<b>S-TYPE</b>	Date <b>03/2001</b>	<b>S501-07</b>
<b>TECHNICAL BULLETIN</b>		
Subject <b>REPLACEMENT OF CENTER CONSOLE ASHTRAY LATCH</b>		Model S-TYPE Year 1999.25 to 2001 VIN L00601 to L86902

### ISSUE: S501-07 - REPLACEMENT OF CENTER CONSOLE ASHTRAY LATCH

Fig. 3

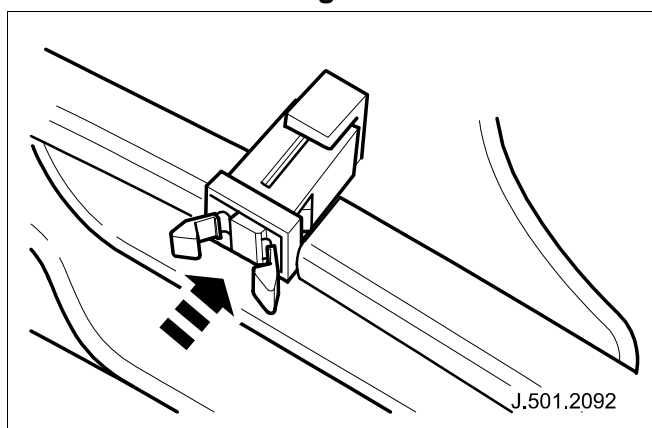
- 6 Fit revised latch into position. (See Fig. 3)

**Note:** If latch claws are not in open state, press the center of the latch mechanism to release the claws.

Fig. 3

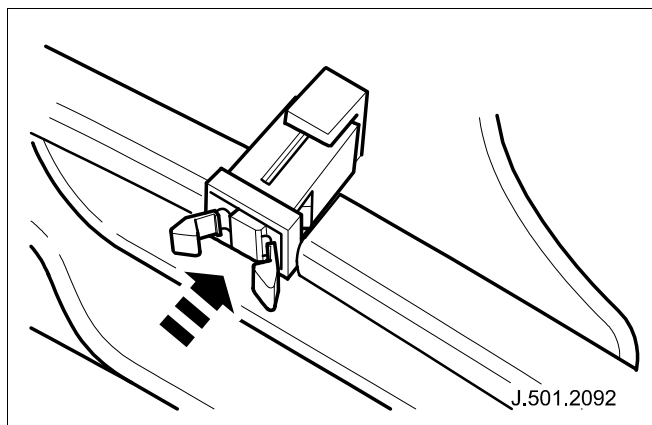
- 7 Fit revised latch into position. (See Fig. 3)

**Note:** If latch claws are not in open state, press the center of the latch mechanism to release the claws.
